Agenda Item # 14

MOD-003753-2026

- Modification of a previously approved Planned Unit Development.

APPLICATION NUMBER	14	DATE	June 18, 2026
APPLICANT	Lukas Benedetto, Piazza Kitchen & Patio		
REQUEST	PUD Modification

SITE PLAN

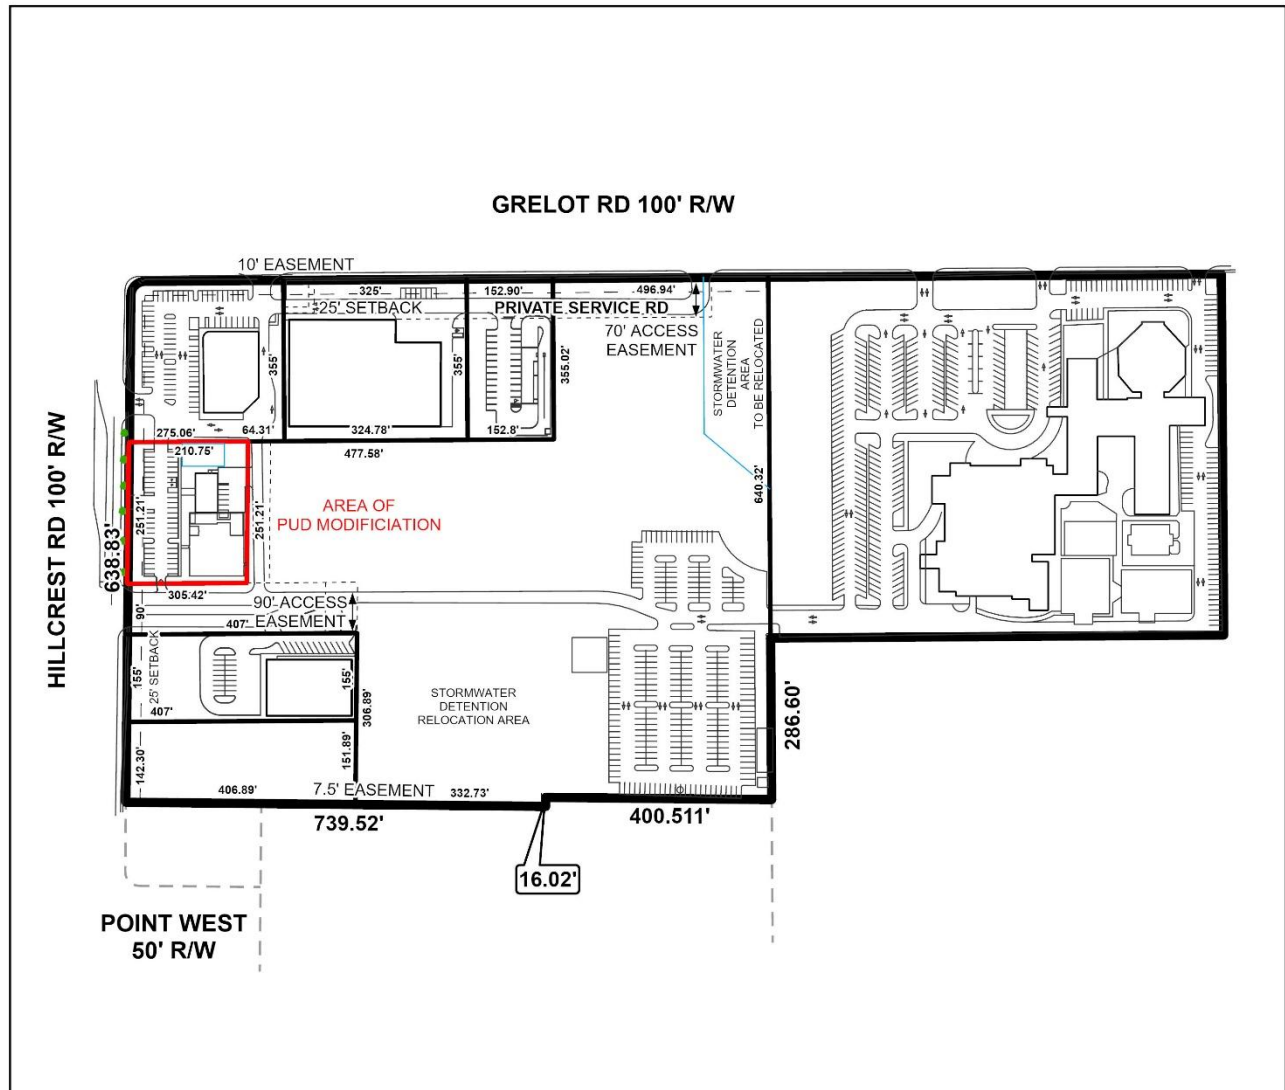
The proposed site plan depicts access to the site via a direct curb cut onto Hillcrest Road, a curb cut connecting to the existing CVS parking lot to the north, and a curb cut connecting to the existing shared driveway to the south. The applicant has submitted authorization from the owner of the CVS property; therefore, the proposed shared access arrangement is permissible.

The submitted site plan depicts a 2,797-square-foot restaurant building, a 2,006-square-foot covered seating area, and both covered and open play areas. Based on the proposed development, a minimum of 17 parking spaces is required. The site plan provides 49 parking spaces, exceeding the minimum requirement by 32 spaces.

Pursuant to the Unified Development Code (UDC), parking spaces provided in excess of the minimum required parking on sites greater than one (1) acre must utilize alternative surfacing. Accordingly, 32 of the proposed parking spaces must comply with this requirement.

Article 3, Section 64-3-12.B., of the UDC requires restaurants to provide off-street loading facilities. Based on the size of the proposed building, one off-street loading space is required. The loading space must be at least 10 feet wide, 20 feet long, and provide a minimum overhead clearance of 10 feet. It is unclear from the submitted site plan whether a compliant loading space is proposed; therefore, any revised site plan should clearly depict an off-street loading space meeting the requirements of Section 64-3-12.B.

Section 64-3-7.A.3.(2)c. of the UDC requires one 9-foot-by-18-foot landscape island for every 12 contiguous parking spaces. The submitted site plan does not appear to demonstrate compliance with this requirement and should be revised accordingly.

No dumpster or dumpster pad is clearly depicted on the site plan. Any dumpster proposed for the site must comply with the enclosure and placement requirements of Article 3, Section 64-3-13.A.4., of the UDC and should be shown on the Final PUD Site Plan. Alternatively, a note may be provided indicating that curbside waste collection will be utilized.

1. Revision of the site plan to depict one (1) nine-foot (9') by eighteen-foot (18') landscape island for every twelve (12) contiguous parking spaces, in compliance with Section 64-3-7.A.3.(2)c. of the UDC;

2. Revision of the site plan to clearly depict one (1) off-street loading space meeting the requirements of Section 64-3-12.B. of the UDC;
3. Revision of the site plan to either clearly depict a dumpster and compliant enclosure in accordance with Section 64-3-13.A.4. of the UDC, or provide a note stating that curbside waste collection will be utilized;

4. Compliance with the alternative surfacing requirements of the UDC for all parking spaces provided in excess of the minimum required parking;
5. Submission of a photometric lighting plan demonstrating compliance with Section 64-3-9.C. of the UDC at the time of permitting;
